UNITED STATES PATENT AND TRADEMARK OFFICE

APPLICATION NO.	FILING DATE	FIRST NAMED INVENTOR	ATTORNEY DOCKET NO.	CONFIRMATION NO.
09/765,014	01/17/2001	Oscar E. Agazzi	36976/NJP/B600	7258
7590	10/18/2005		EXAMINER	
CHRISTOPHER C. WINSLADE MCANDREWS, HELD & MALLOY 500 W. MADISON STREET SUITE 3400 CHICAGO, IL 60661			KIM, DAVID S	
			ART UNIT	PAPER NUMBER
			2633	
			DATE MAILED: 10/18/2005

Office Action Summary	Application No.	Applicant(s)
	09/765,014	AGAZZI, OSCAR E.
Examiner	Art Unit	
David S. Kim	2633

DETAILED ACTION

FIG. 5

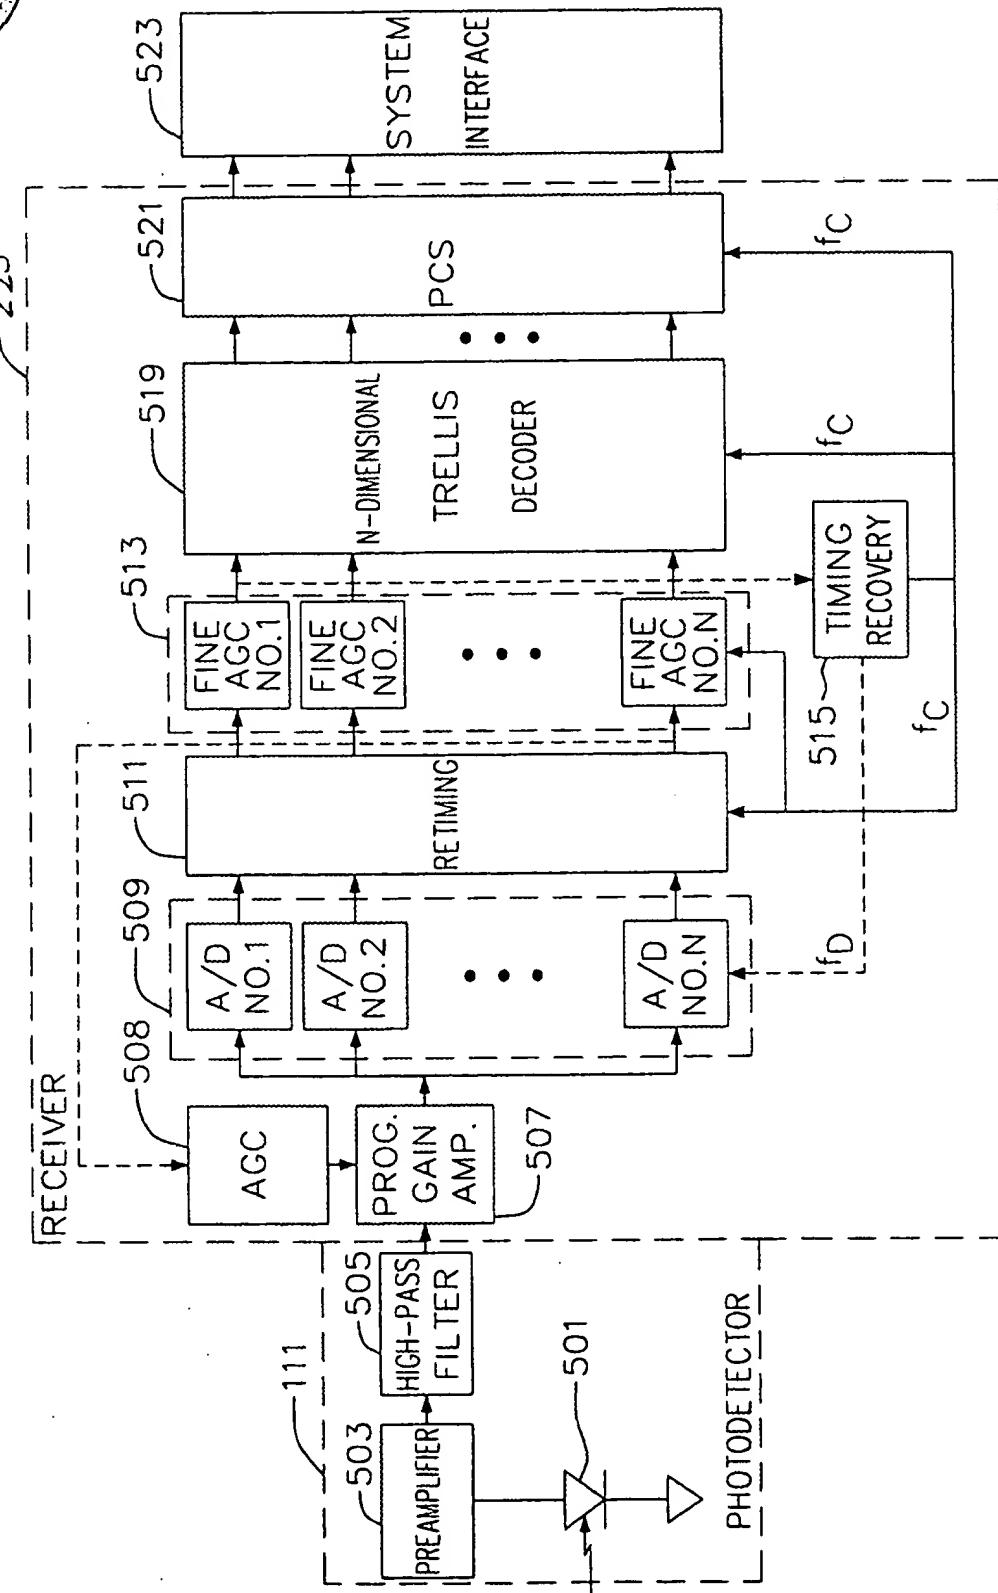
Fig. 5 is disapproved because reference character "111" is used where -- 215 -- may be intended.

Disapproved by DSK
 05 OCTOBER 2005
